# Modification of Development Consent

**For the following:** Construction, fit-out and operation of a five-storey advanced manufacturing research facility with café, parking and landscaping

**Modification Application:** SSD-58591961-Mod-1

Modification to permit staged delivery of Building 2, remove basement car parking and amend the development layout

Figure 1: Stage 1 – Site Plan

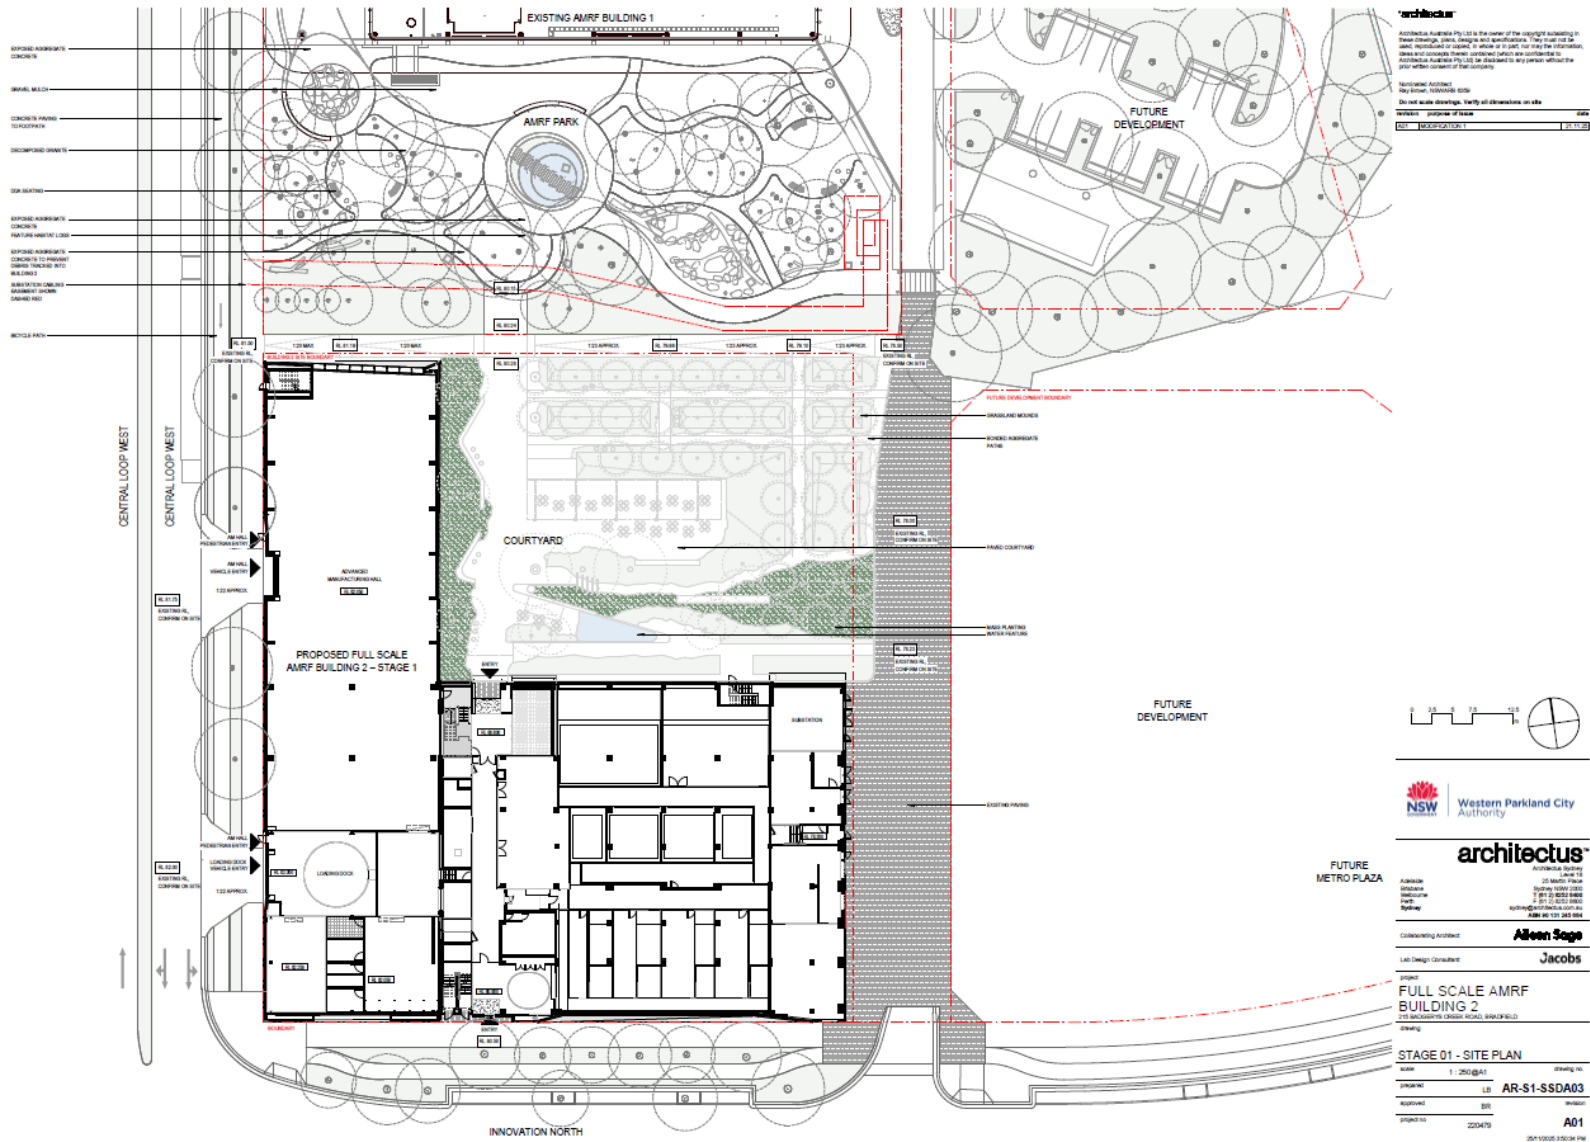
13. Delete condition B39 and replace with new condition B39 as follows:
- B32. The quantities of dangerous goods stored and handled at the site, must be below the threshold quantities in the Department’s *Hazardous and Offensive Development Application Guidelines – Applying SEPP 33* at all times. Under this condition, any threshold quantities requiring measurement of distance to a lot boundary must use the ‘Building 2 Site Boundary’ as shown in Figure 1 and Figure 2 in Appendix 1 as the lot boundary.

16. Delete Appendix 1 and replace with new Appendix 1 as shown in Appendix A of this instrument.
17. In Appendix 2 Applicant's Management and Mitigation Measures:
  - a. in the section titled Traffic, transport & Accessibility, TTA5: Car Parking delete the words "A minimum 18 car parking spaces will be provided on site to service the neighbouring AMRF Building 1" with the following words "Prior to operation, a minimum of 32 car parking spaces will be provided within 250m walking distance of the site, within a safe and accessible path of travel."
  - b. in the section titled Ecologically Sustainable Development (ESD) delete the words "November 2023" and replace with the words "November 2025".
